DRAFT DECISION
Multinet Gas
Access arrangement
2018 to 2022

Attachment 6 – Capital
expenditure

July 2017

Figure 6.1 Distribution mains leak incident rate by pressure

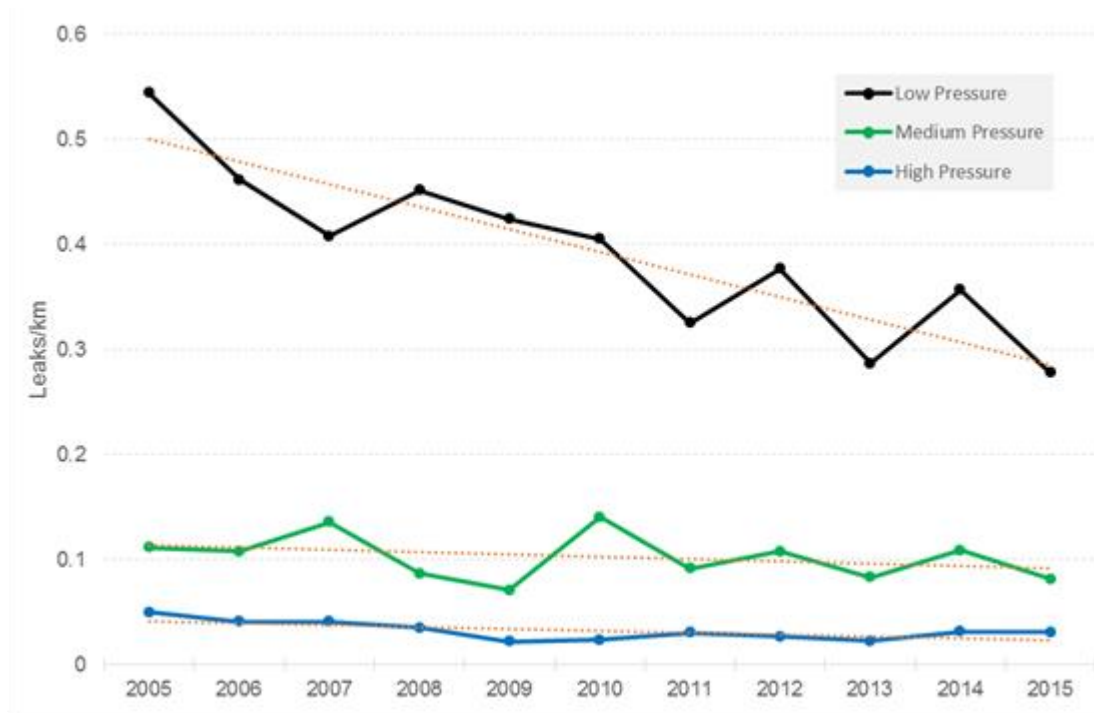
The historical leakage data Multinet provided reveals that leaks per kilometre for low pressure mains have declined from 0.54 in 2005 to 0.28 in 2015. However, between

2005 and 2015 these mains still had the highest average leak rate, with 4.3 leaks per kilometre, compared to 1.1 leaks per kilometre for medium pressure mains and 0.35 for high pressure mains. This data supports Multinet's approach of focusing on proactive mains replacement of its low pressure mains.³¹

Figure 6.1 above also shows Multinet's declining leak incident rates for the low pressure network. The leak incident rate has decreased from 0.54 leaks per kilometre in 2005 to 0.28 leaks per kilometre in 2015. This is a 48 per cent reduction and, as Multinet submitted, indicative of improvements in network integrity and public safety resulting from the targeted and proactive replacement of the low pressure network.³⁶

Figure 6.4 Cast iron fracture incident rate comparison by pressure

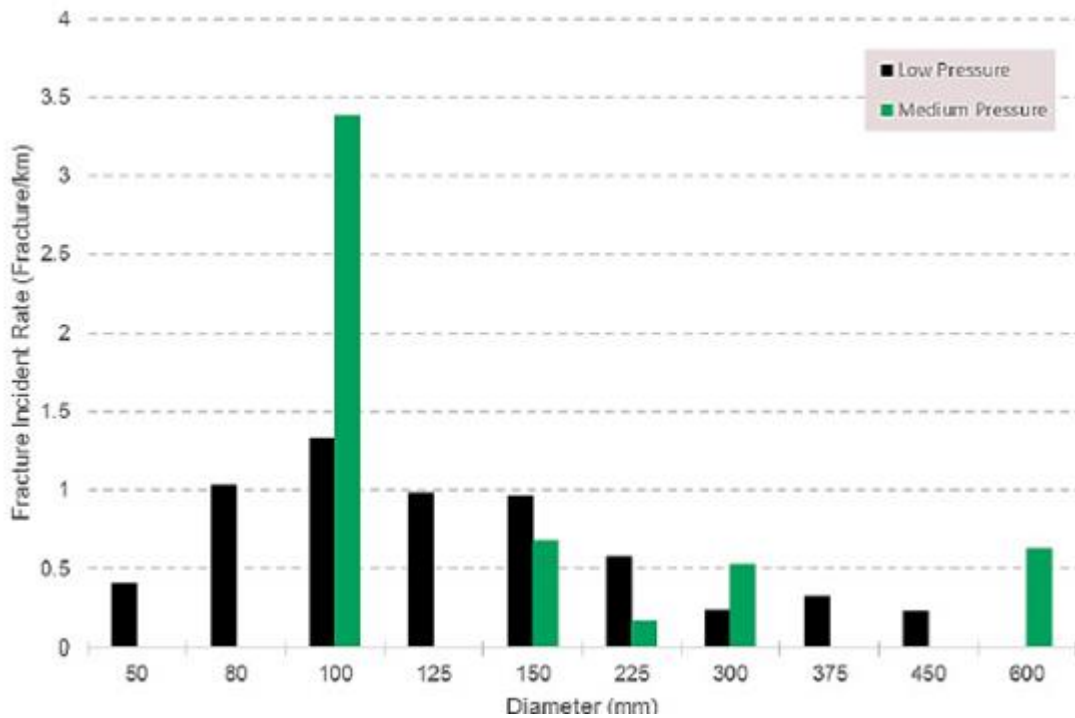
First, we examined the leak and fracture rates on both the low and medium pressure networks. The probability of failure on the medium pressure network is lower: in 2015 the leak rates were respectively 0.08 and 0.28.⁴⁶ This is illustrated in Figure 6.3 and Figure 6.4.

Multinet submitted that although medium pressure cast iron mains have a lower probability of failure relative to low pressure mains, the combination of higher operating pressures, critical supply and high density geographic location places these assets as 'high risk' from a consequence perspective in comparison to that of the overall low pressure cast iron network.⁴⁷

Zincara acknowledged the greater consequence of a medium pressure mains fracture incident. However, Zincara also notes that the number of incidents has been very low and these have been managed through operations and maintenance.⁴⁸ There is nothing in the available information to suggest this approach should change.

Figure 6.5 Multinet's historical and forecast Tariff V connection volumes

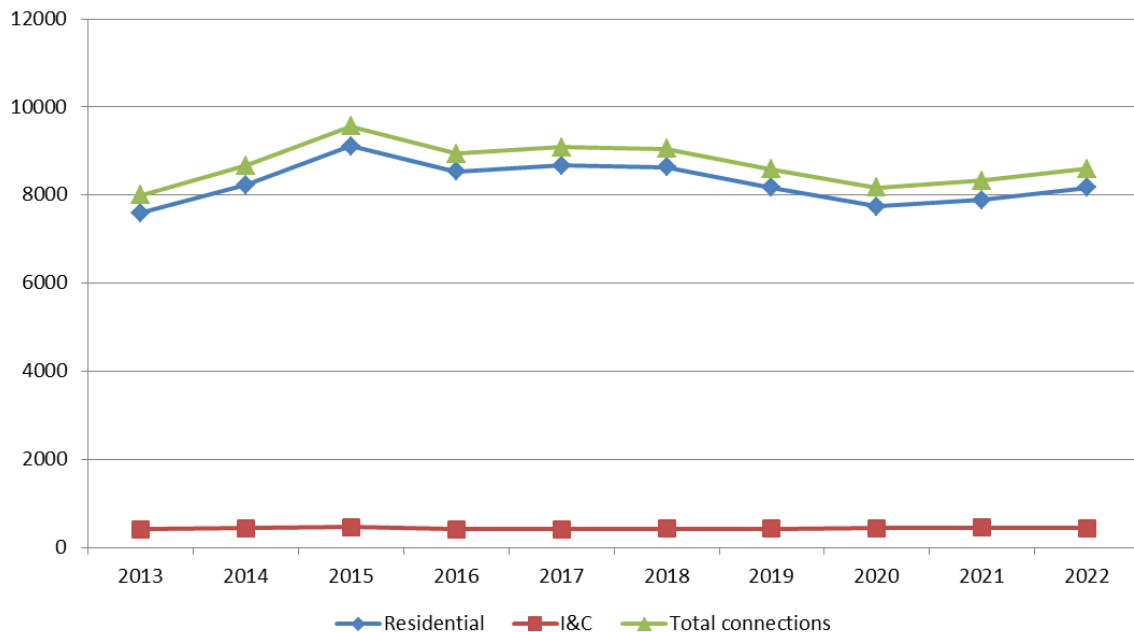
In summary, Multinet forecasts an increase in total net residential and I&C connections of 0.54 and -0.95 per cent per annum respectively.⁸⁰ These forecast growth rates are similar to the 0.59 per cent (residential) and -0.94 per cent (I&C) growth rates experienced during the 2013–17 access arrangement period. While forecast net connections are relevant for demand forecasting purposes, forecast gross connections (that is, net connections plus disconnections) are used to determine connections capex. As noted above, Multinet has forecast volumes of gross connections.

Figure 6.5 shows the historical trend and forecast of Multinet's residential and I&C connections. Residential connections make up the vast majority of total connections, and are forecast to fall in 2019 and 2020 before recovering. I&C connections are expected to remain stable at approximately 430 connections per year.

Figure 6.6 Comparison of ICT capex across previous, current and forthcoming access arrangement period (\$m, real \$2017)

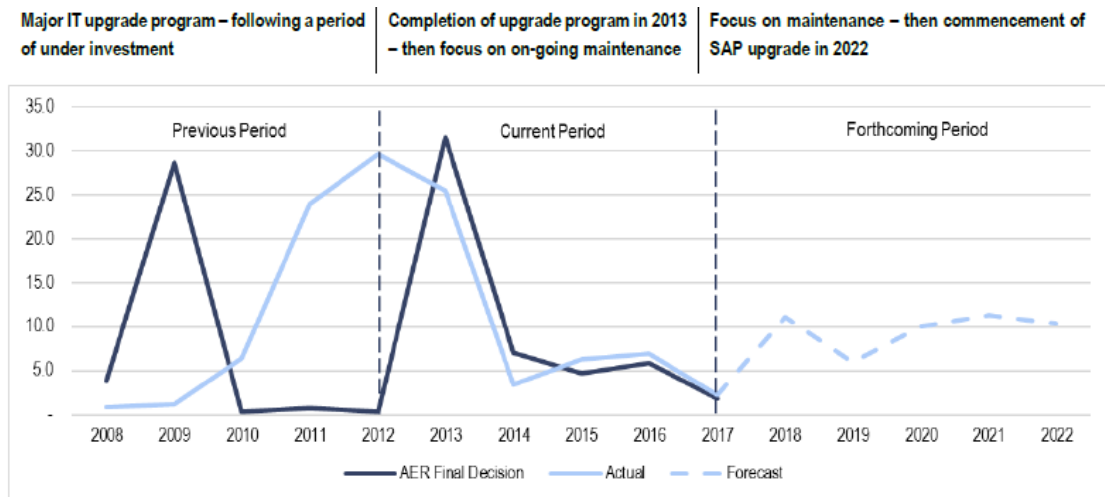
Multinet proposed \$45.7 million (\$2017, unescalated direct costs) for non-network ICT capex. Figure 6.6 shows a time series of Multinet's ICT capex from 2008 to 2017 relative to capex approved by us, and Multinet's forecast for the 2018–22 access arrangement period. As can be seen, Multinet has invested heavily in ICT capex in the 2013–17 access arrangement period. Multinet submitted that this expenditure brings its ICT systems up to the required standard and will deliver systems that meet the requirements of its business transformation following several years of under-investment.⁹²

Figure 6.6 also shows that Multinet has proposed higher ICT capex for the 2018–22 access arrangement period than it spent in the 2013–17 access arrangement period. Most of this expenditure is recurrent capex which Multinet submits is to ensure that it meets the information needs of its customers, maintains the integrity of its services and achieves the levels of demand required by customers. The proposed increase is due to the timing of the required maintenance of its systems.⁹³
